Applies To: 1997 Prelude – with A/T thru VIN JHMBB6...VC012298

April 21, 1997

## MIL Stays On After Starting / DTCs P1768 and P1773

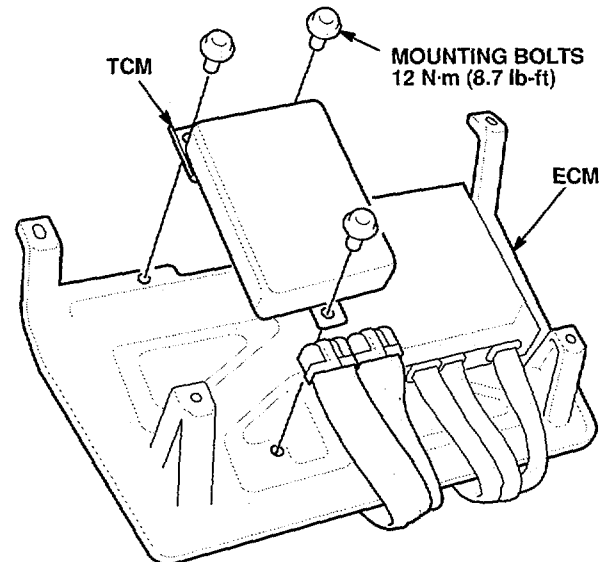
1. Remove the passenger's side door sill molding.
2. Pull the passenger's side carpet back to expose the ECM cover.
3. Remove the ECM cover mounting nuts, then turn the ECM cover over.
4. Remove the TCM by disconnecting the two connectors and removing the three mounting bolts.

5. Install the new TCM in the reverse order of removal, and reinstall all removed parts.
6. Record the customer's radio station presets, and the radio anti-theft code.
7. Pull the BACK-UP (10 A) fuse from the under-hood fuse box for 10 seconds to reset the ECM and the TCM.
8. Enter the radio anti-theft code and the customer's radio station presets. Reset the clock.
